City of Carpinteria
Architectural Review Board Agenda
Thursday, March 26, 2026
Council Chamber, 5775 Carpinteria Avenue,
Carpinteria, CA 93013

**CITY OF CARPINTERIA
ARCHITECTURAL REVIEW BOARD
Meeting of March 26, 2026**

Project: 25-2372-CDP/ARB **Planner:** Bret McNulty
Address: 5538 Canalino Drive
APN: 003-382-012
Zoning: Single Family Residential (6-R-1)
Applicant: Robert Mahterian, architect, for Keith and Lesley Marvin

Existing Single Family Residence Remodel
5583 Canalino Drive
Project #25-2372-CDP/ARB
Preliminary ARB Review
March 26, 2026

MATERIAL BOARD

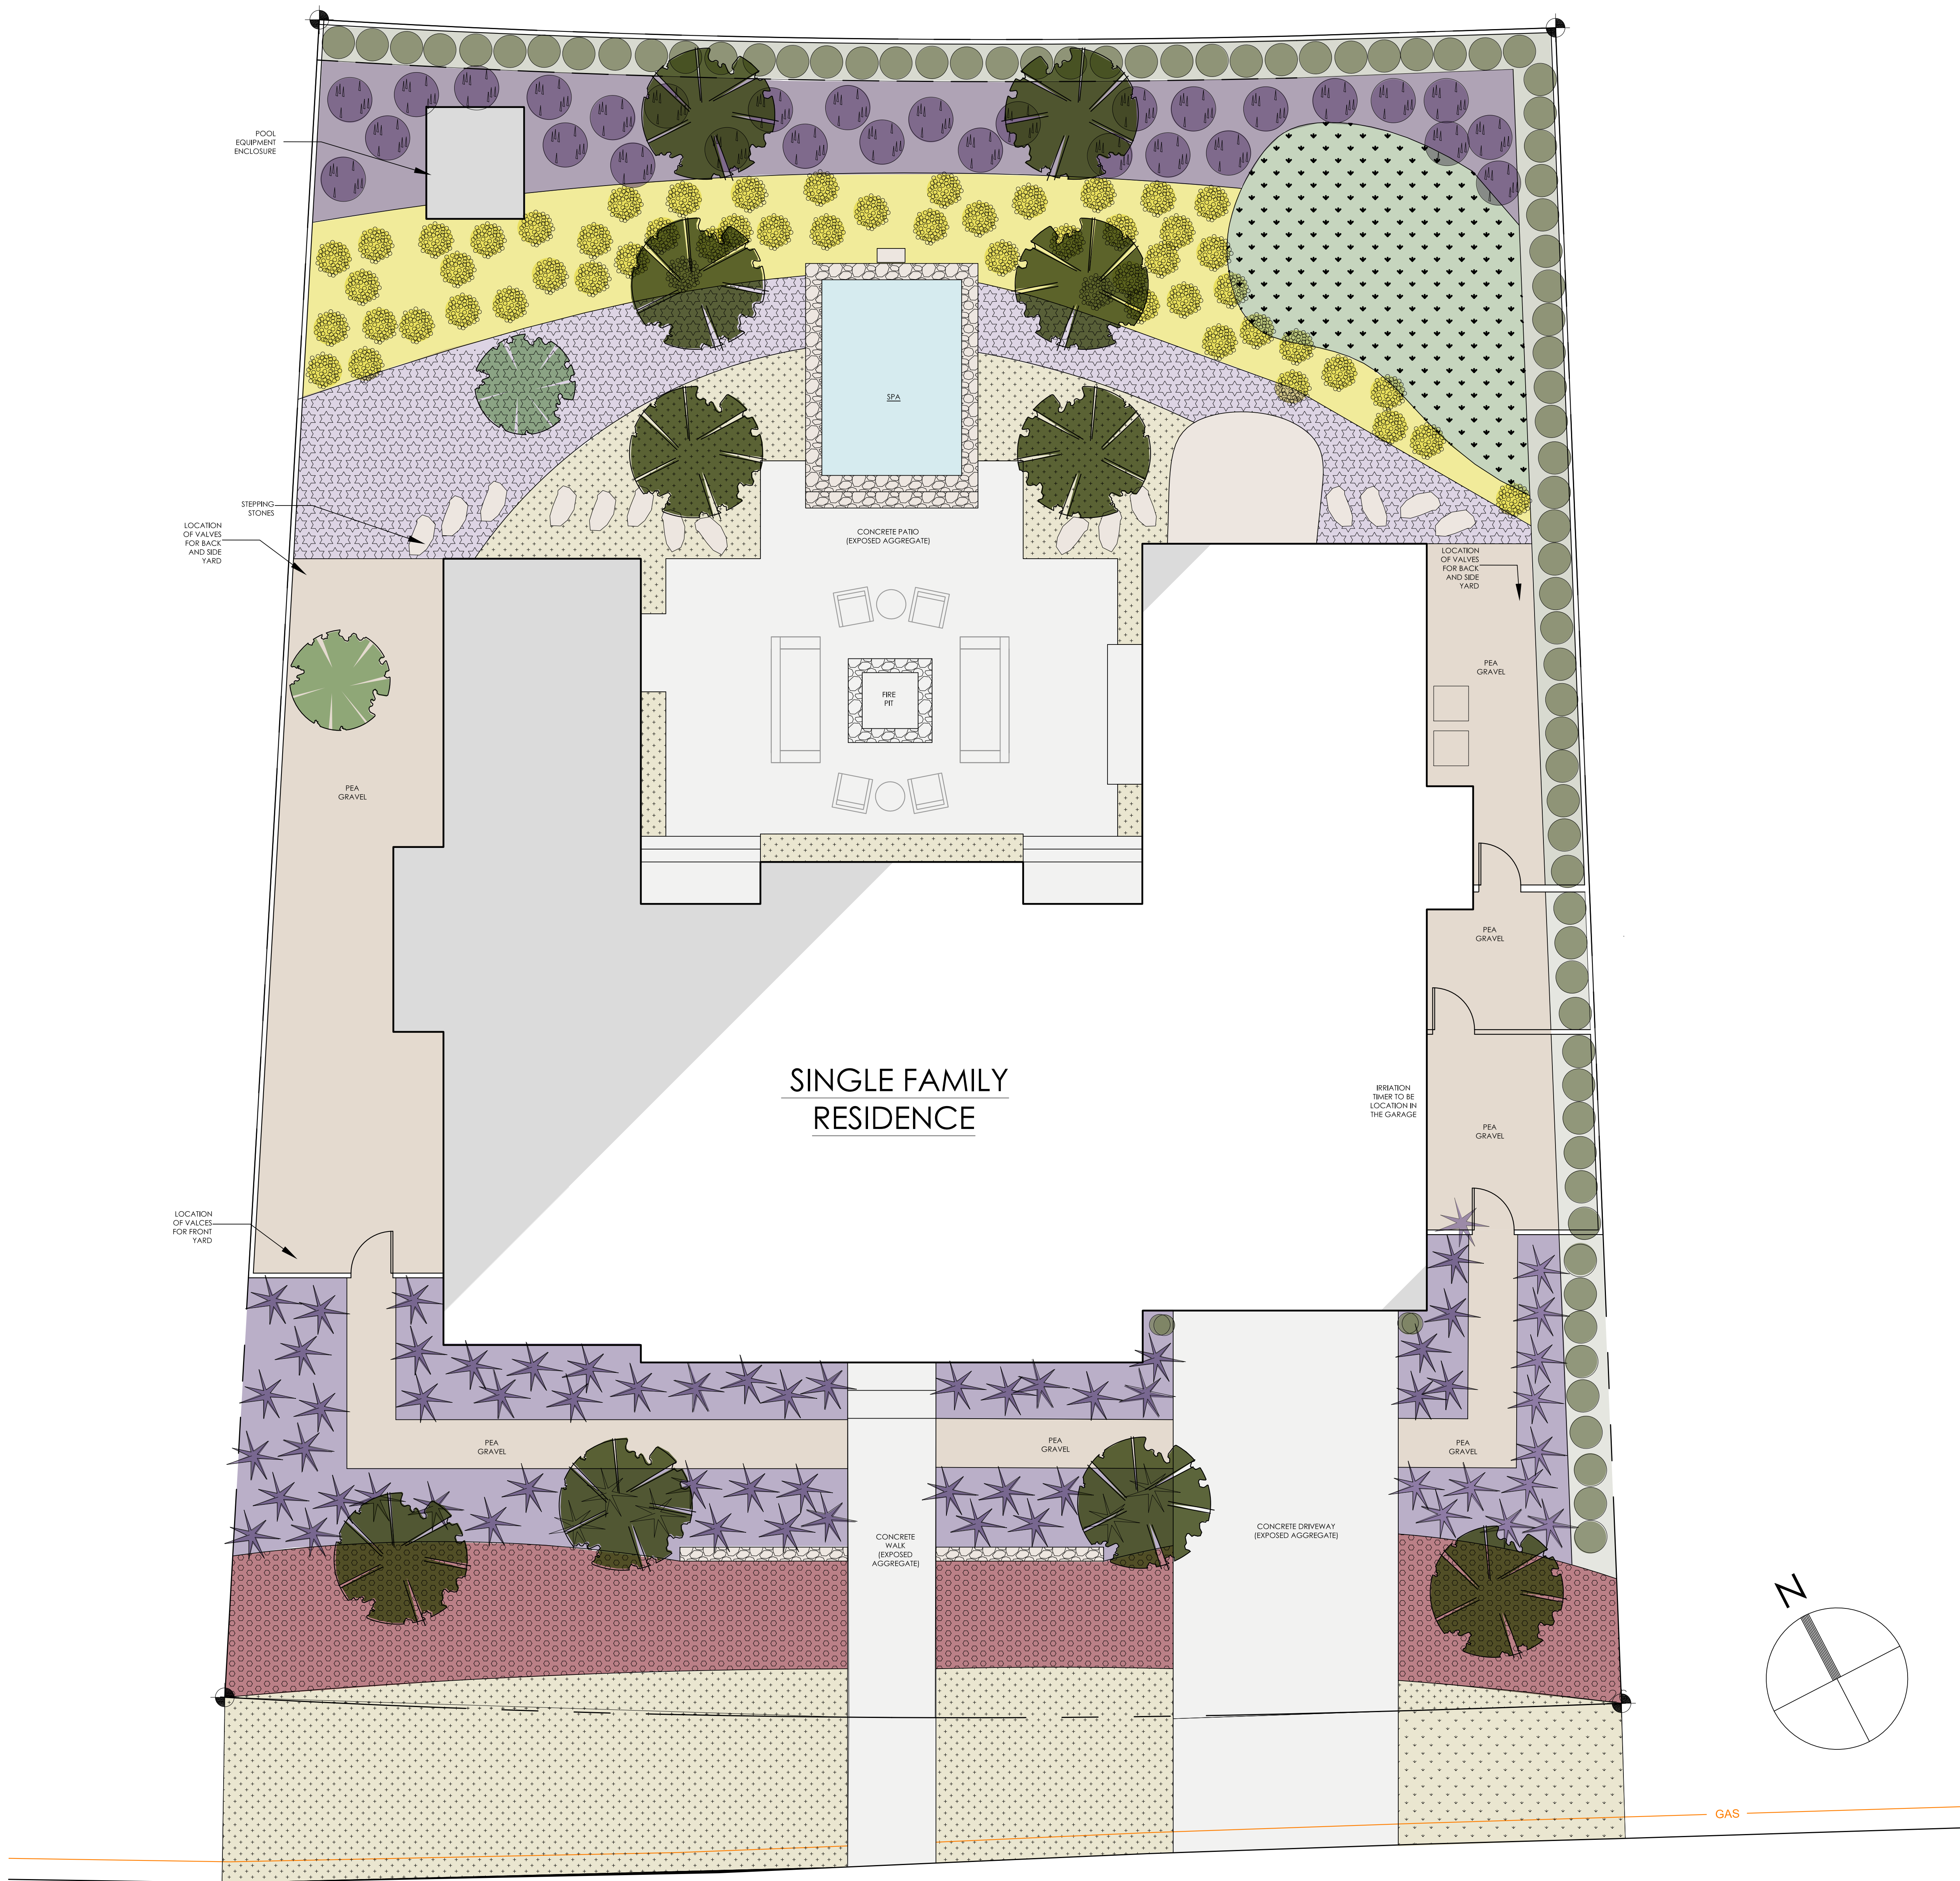
The proposed materials are typical for a modern house, such as cedar wood siding and light colored stucco with a darker metal roof. The proposed materials would impart a contrast with a darker brown siding and dark bronze window frames that are tied together by the use of lighter (stone and rust) colors. The use of these materials in concert with the chosen architectural style lends the home a mix of earthen tones impart a character that is unique and compatible with the colors and architectural designs and one-story residences in this neighborhood.

The Board should comment on neighborhood compatibility, and the proposed fencing, landscaping, hardscape, and materials.
